STATE OF NORTH CAROLINA
DEPARTMENT OF TRANSPORTATION

Subject: **Request for Modification to Section 404 Nationwide Permit 23 and Section 401 Water Quality Certification** for the replacement of Bridge No. 25 over the Waccamaw River Overflow on NC 130, Columbus County; State Project No. 8.1431901; TIP No. B-4077. Debit \$240 from WBS 33439.1.1.

Reference: Original Permit application dated March 7, 2008.
U.S. Army Corps of Engineers, Section 404 Nationwide Permit 23 issued April 3, 2008; Action ID 200801063.
N.C. Division of Water Quality Section 401 Water Quality Certification issued April 14, 2008; Project No. 080503.
Notification of Design Changes dated May 12, 2008.

Permit Drawing
 Sheet 5 of 5

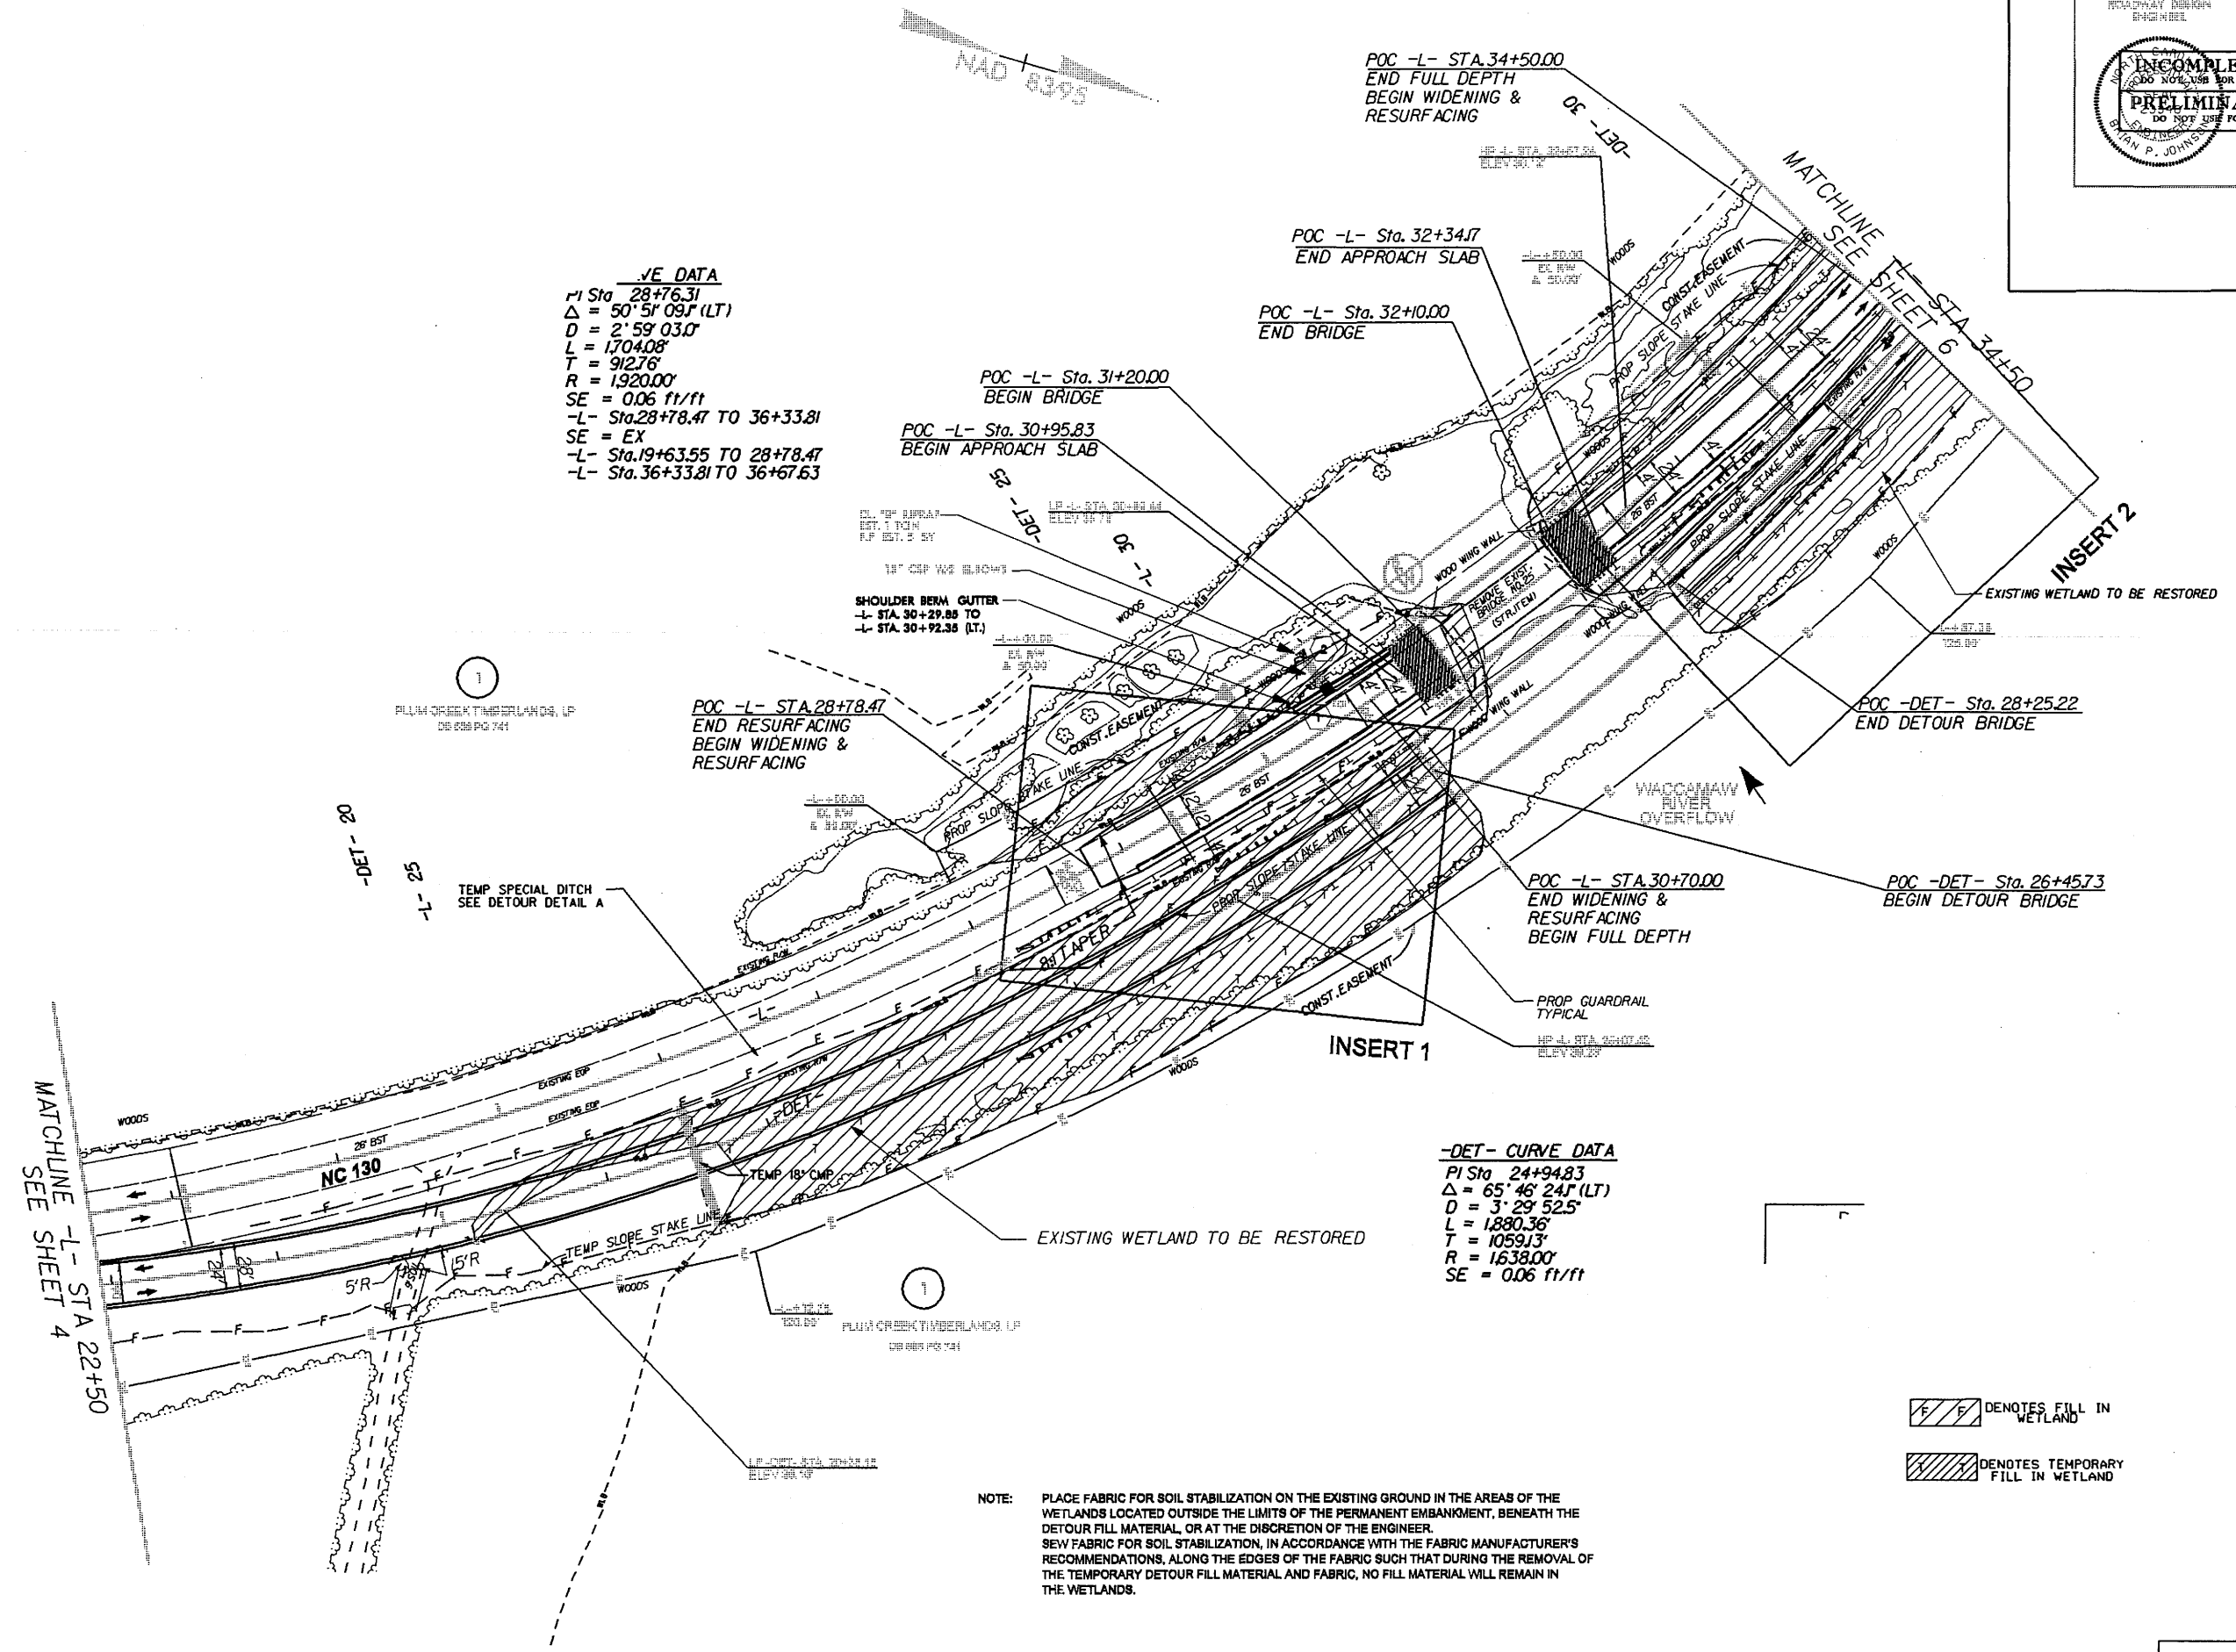
NCDOT has determined that the changes detailed in the May 12, 2008 letter have necessitated an increase in the amount of rip rap required under the proposed bridge. The additional rip rap has increased the permanent impacts to jurisdictional resources from 0.47 ac to 0.48 ac. Mitigation for this project is being debited from the Juniper Bay Mitigation site located in HU 03040203. The debit ledger for this mitigation site has been updated to reflect the increase in mitigation needed and is shown in Table 1 below.
